Re: Paric Corporation Project No. 15051
15051-Webster University Interdisciplinary Science Building
CP-032 - ASI#24 Plumbing RFIs

Architect's Supplemental Instructions

Project:
Webster University
Interdisciplinary Science
Building

Description: ASI – 024 (RFI-222, 233, 235 & 236)

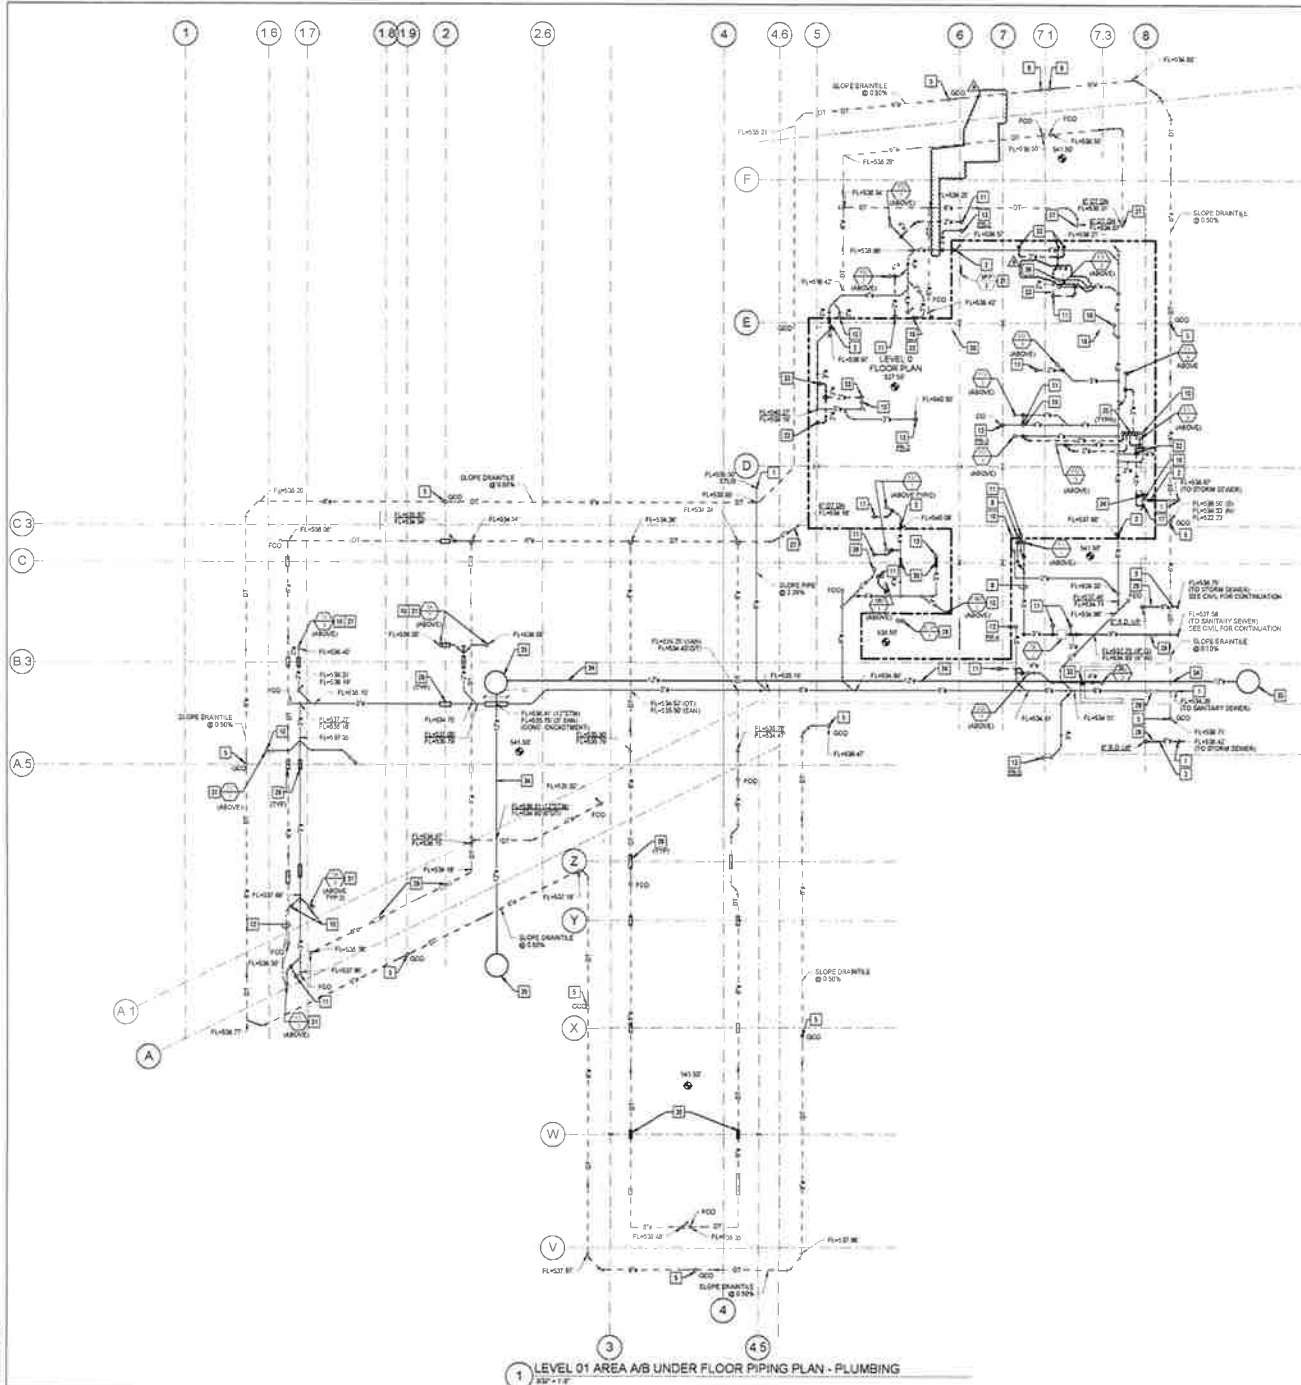
RFI-235, (P0101.A & P0403); Revise 8-inch combination fire and domestic water service as noted. Remove 8-inch building service valve as indicated. Install new 4-inch domestic valve on 4-inch domestic service line as shown on drawings P0101.A and riser diagram sheet P0403. Relocate pressure gauge as indicated on plans.

P0101.A

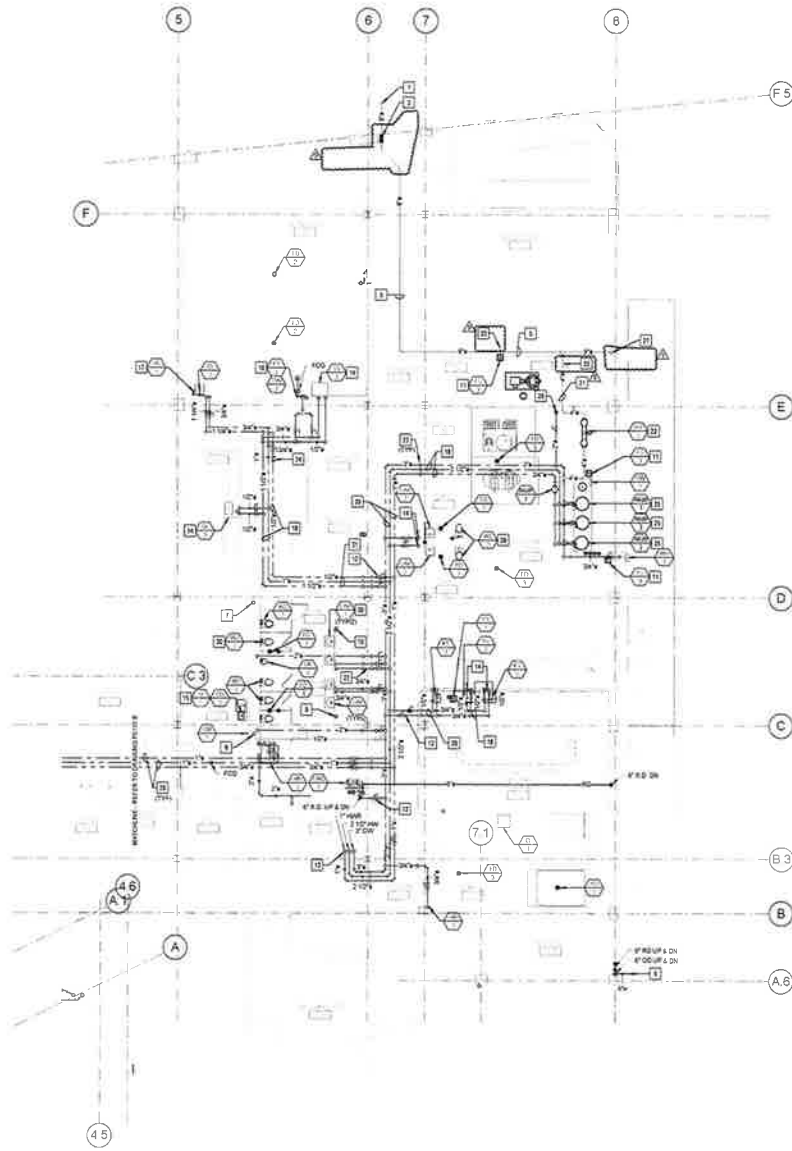
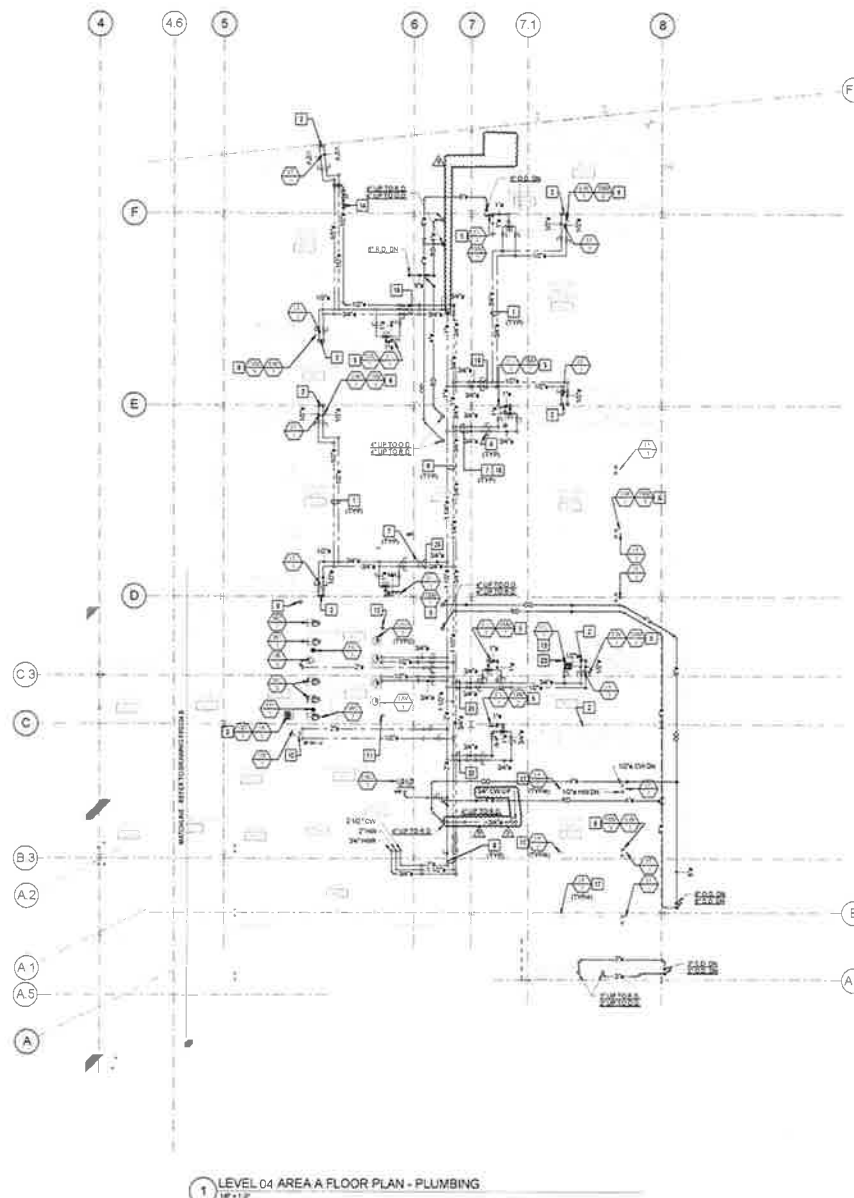
RFI-222, (P0011 & P0111.A); Provide and install 4" CI Standpipe 2 feet above finish floor for sprinkler system drainage. Refer to sheets P0011, P0101.A & P0111.A.

P0105.A

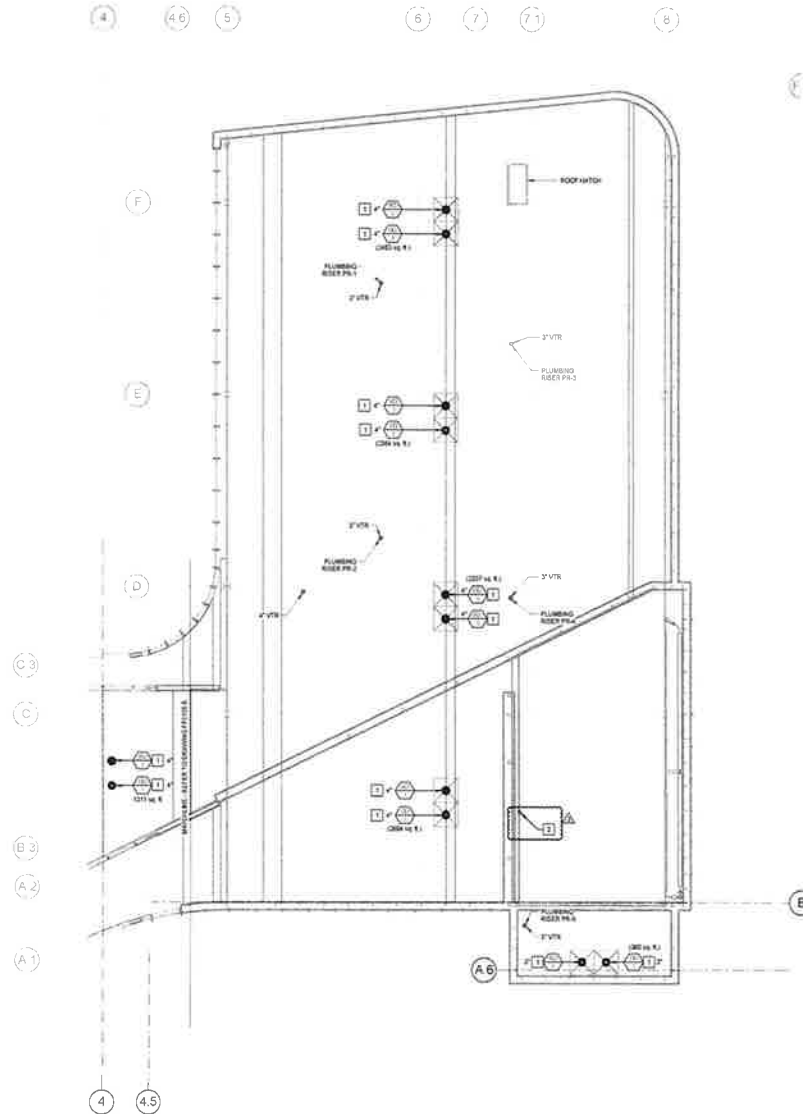
RFI-236, (P0104.A, P0111.A & P0105.A); Provide and install ¾" CW service up through roof to serve Non-Freeze Sanitary Roof Hydrant, Jay R. Smith model 5903 or equal. Refer to sheets P0104.A, P0111.A and P0105.A for all changes. Coordinate exact location of hydrant with Architect prior to rough-in.
